# HISTORIC DISTRICT COMMISSION

## ADDITIONAL INFORMATION REQUEST

**Application Number:** HDC2025-00129

<b>NAME:</b> Alton G Smith		<b>COMPANY NAME:</b> Smith Ball LLC	
<b>ADDRESS:</b> 1001 Bishop Rd	<b>CITY:</b> Grosse Pointe Park	<b>STATE:</b> MI	<b>ZIP:</b> 48230
<b>PROJECT ADDRESS:</b> 863 Iroquois			
<b>HISTORIC DISTRICT:</b> Indian Village

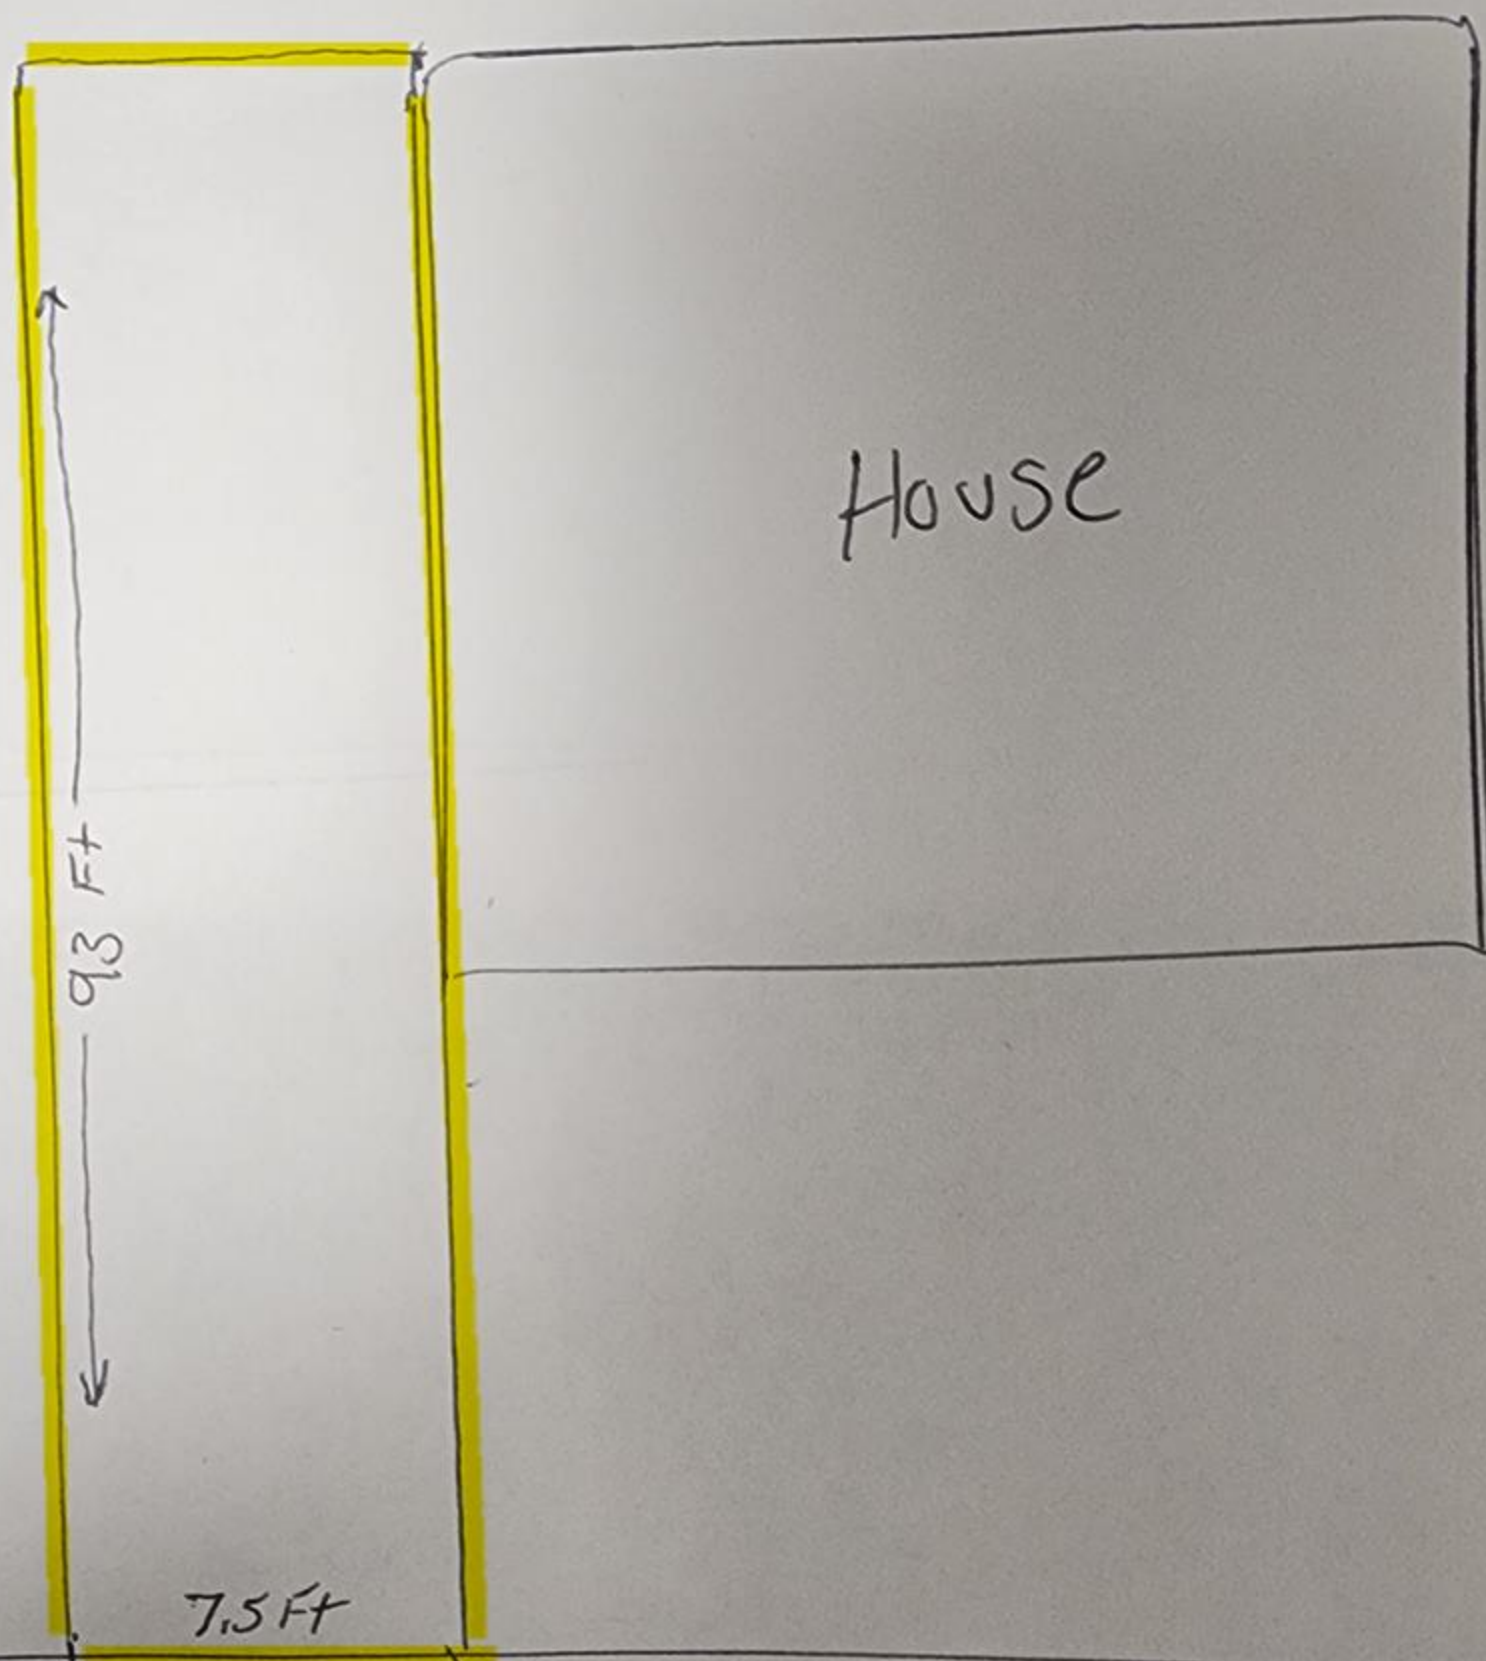
6/02 - Concrete driveway –a site plan (hand drawn is fine) with dimensions of existing/proposed driveway footprint noted is necessary.

8/28 – the mocked-up photo is helpful, but we still need to receive a dimensioned footprint/site plan that states the overall dimensions and clearly shows where the driveway will begin and end.

proposed driveway replacement will be 93x 7.5ft extending from the back edge of the house to the city sidewalk. it will not include city sidewalk and below. see attached photos.

4 Fluted Pilasters  
Existing

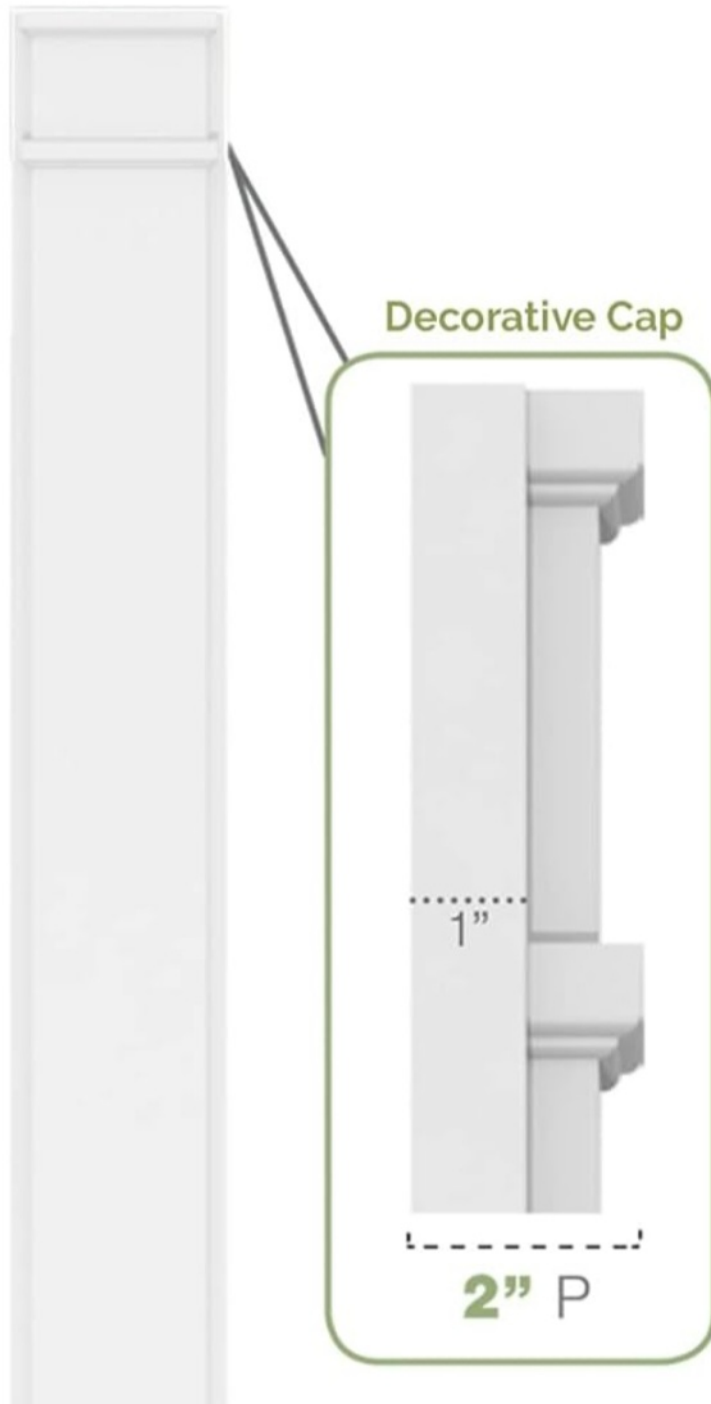
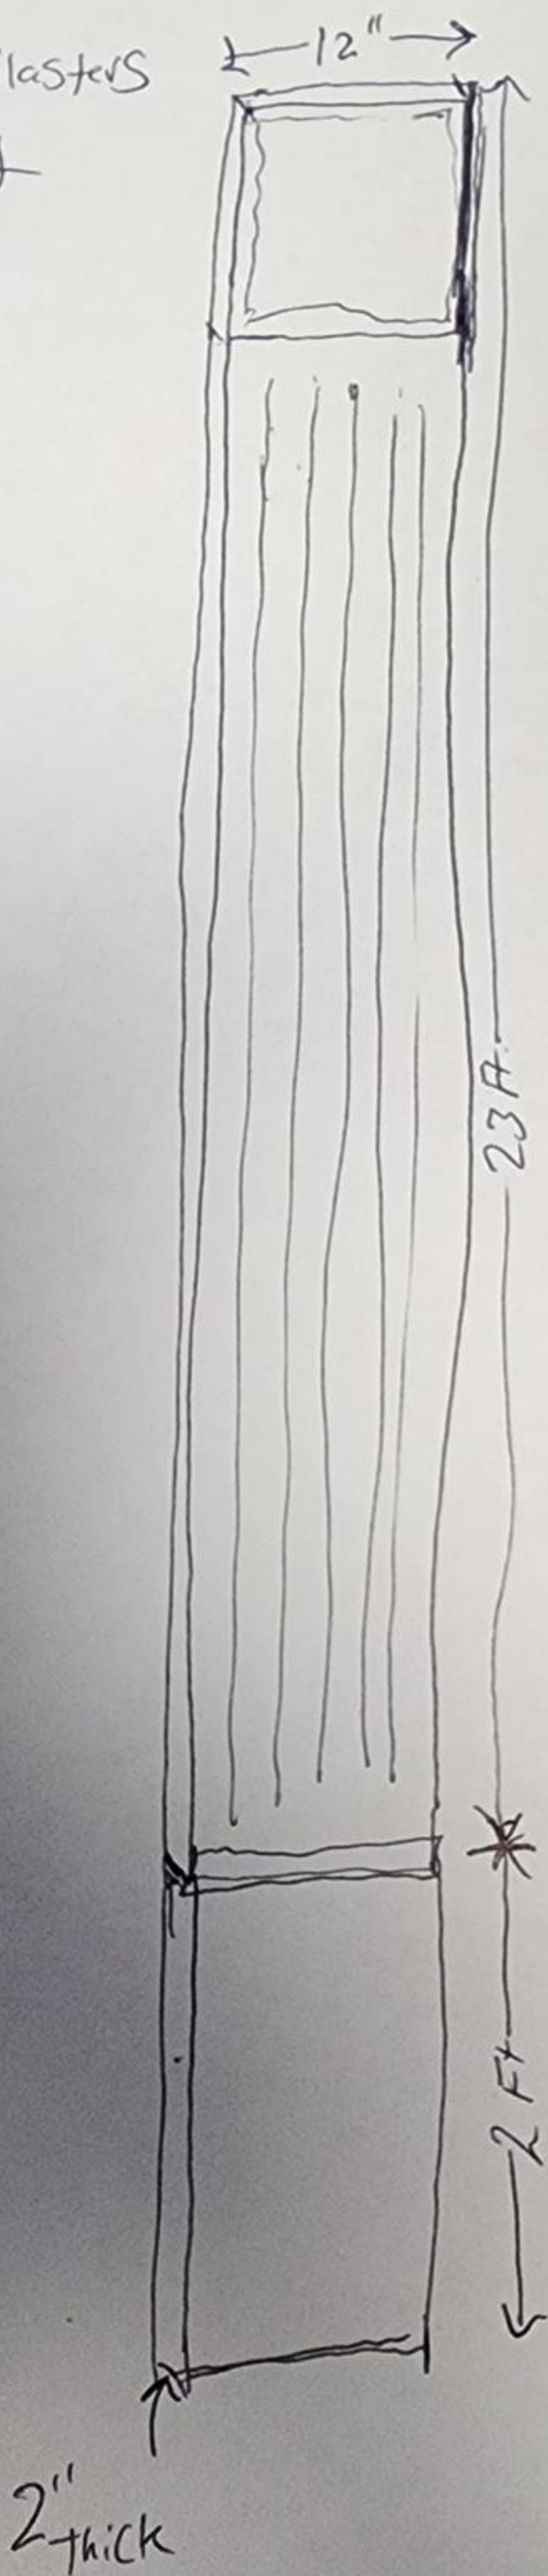
It appears the outside square column has been replaced in violation. The new column design does not match the historic column design. Staff does not have authority to approve this replacement column.

There are 4 pilasters that make up the outside columns on the front corners of the house. these were in significant decay and were replaced in violation. I sincerely apologize for this. I have attached a proposed for replacement of the original pilasters (12 inches in width x 25ft Length x 2inch depth} . see attached cut sheet (Fluted column).

Porch Center Column  
Existing.

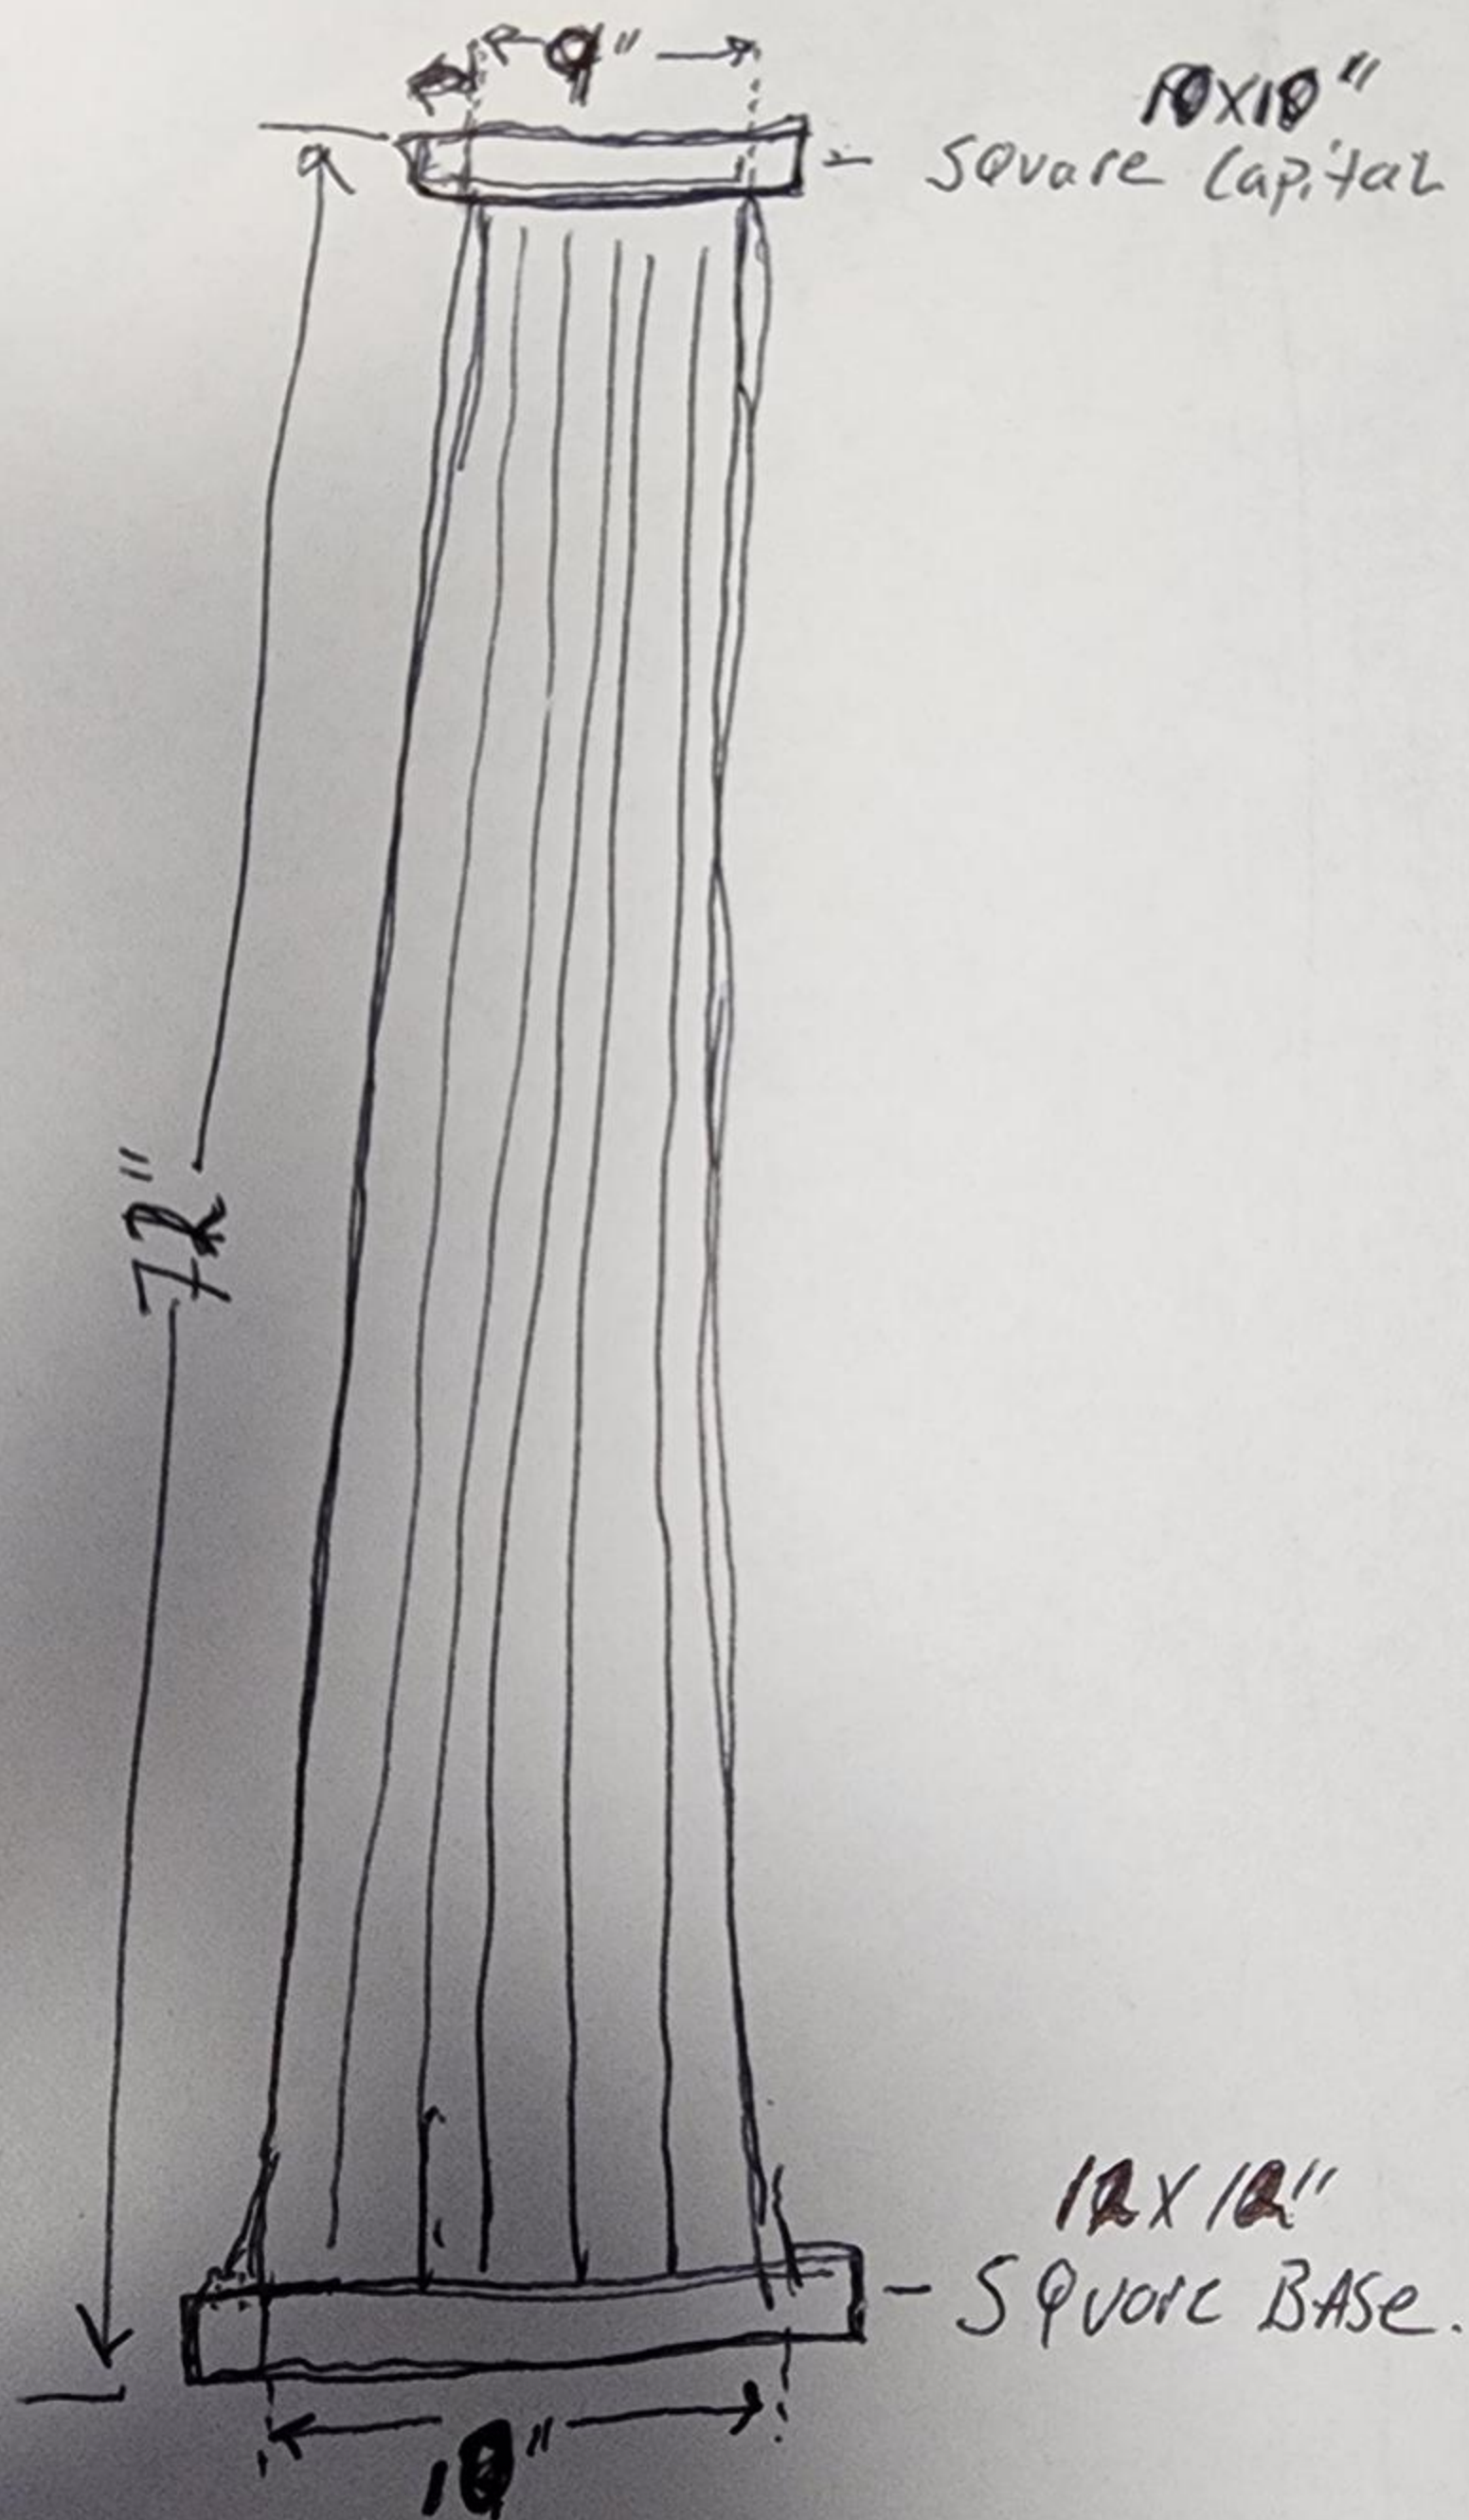
8/28 – Staff doesn't have authority to approve replacement columns, except for the central column that is partially missing. As stated above, dimensions of the existing column (width of shaft, and base and capitol detailing) are needed, as well as the cut sheet for the proposed column that shows the design and all dimensions, material and finish, are required for review.

The central column on the porch is 6ft in height, tapered and fluted with a 9 inch diameter at the top and a 10 inch diameter at the base. it has a 10 inch Tuscan capitol and a 12 inch Tuscan base. the proposed central column has identical dimensions and will be finished in white to match the existing trim.

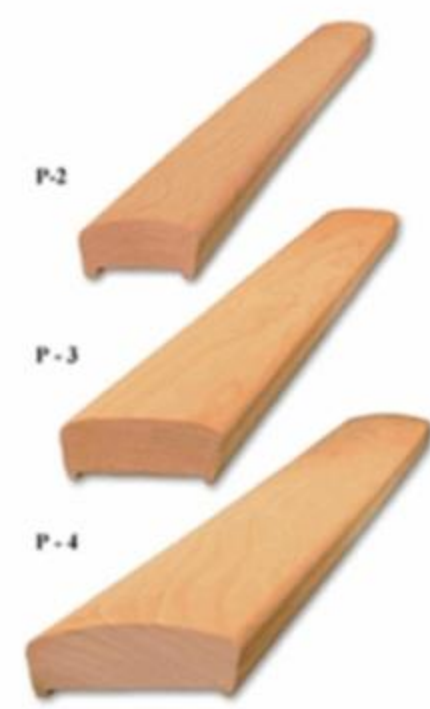
Staff notes that no mention has been made of the porch railing. Based on a staff photo of this house, dated July 14, 2025, a portion of the railing remains intact on the side. Please include specifications for the retention of the side railing as well as a cut sheet or dimensioned drawing for the railing planned for the front of the porch. Also include information on whether a railing for the front steps is proposed. If so, please submit a dimensioned drawing confirming the placement, design, material, and finish.

As mentioned the existing porch railing on the north side of the house is in good condition and will only need painting. (White to match existing trim) additional railing will be added to porch between center column and north corner of porch.
